# rts\_forward\_timer duration concern

Jeff Slavick – Broadcom  
Xuebo Wang – Huawei

# The concern is with rts\_forward\_timer min duration

Figure 178B-9—RTS update state diagram

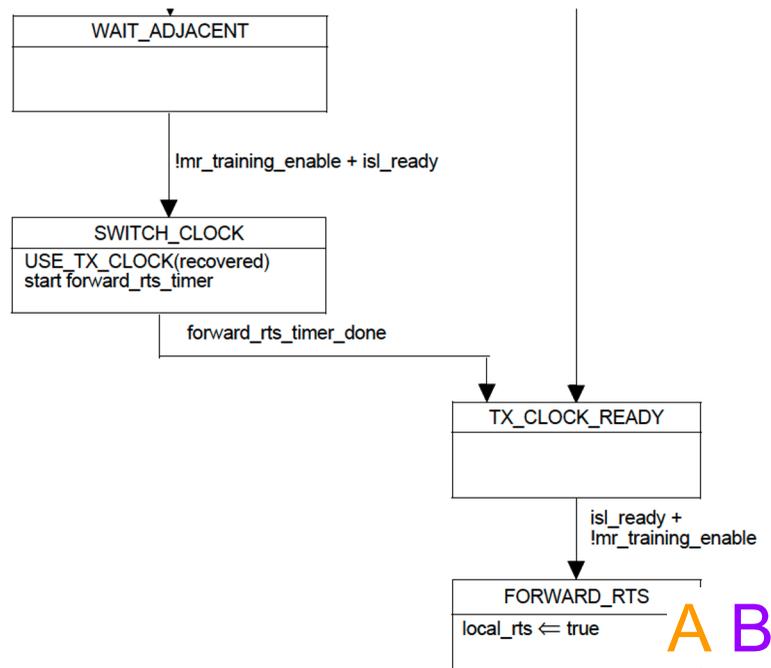
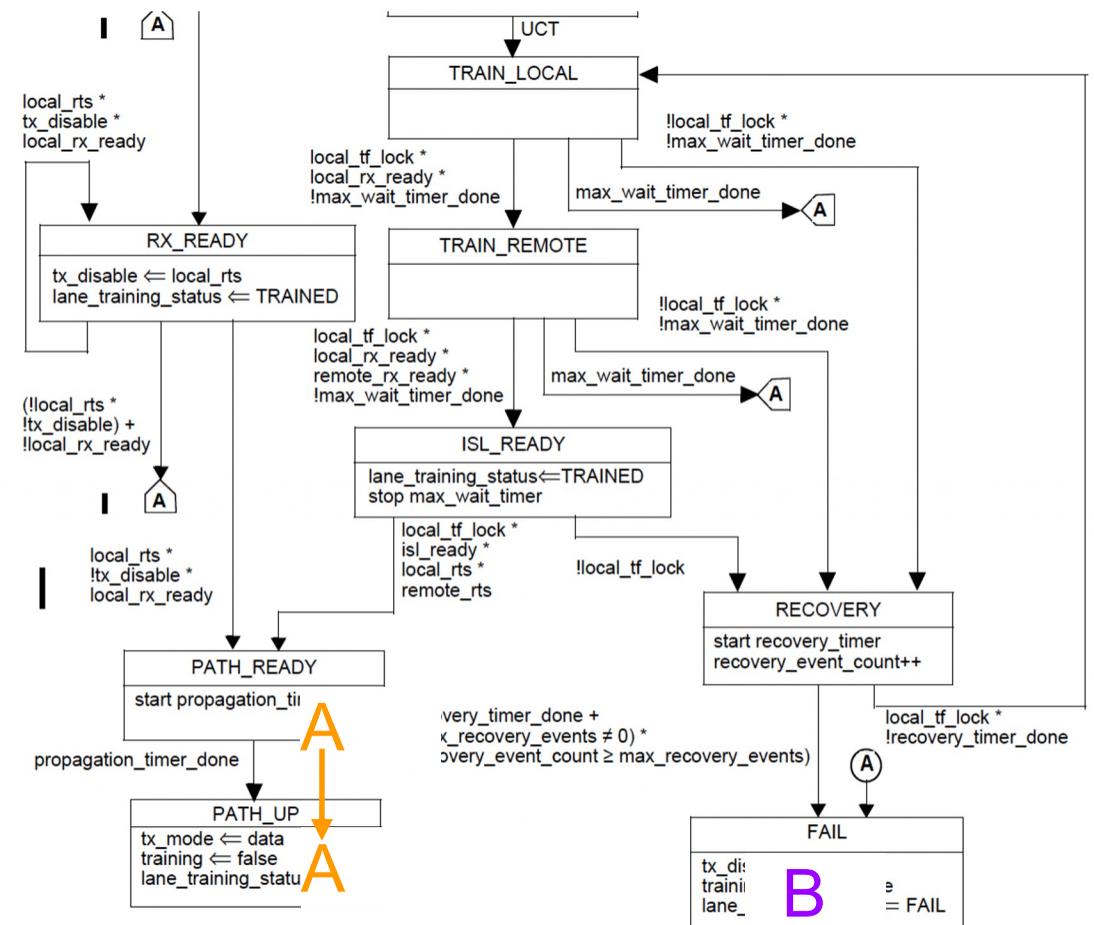
Interface A moves to PATH\_UP after propagation\_timer expires.

The peer interfaces did not end up in the same place!  
(both should be in FAIL or PATH\_UP)
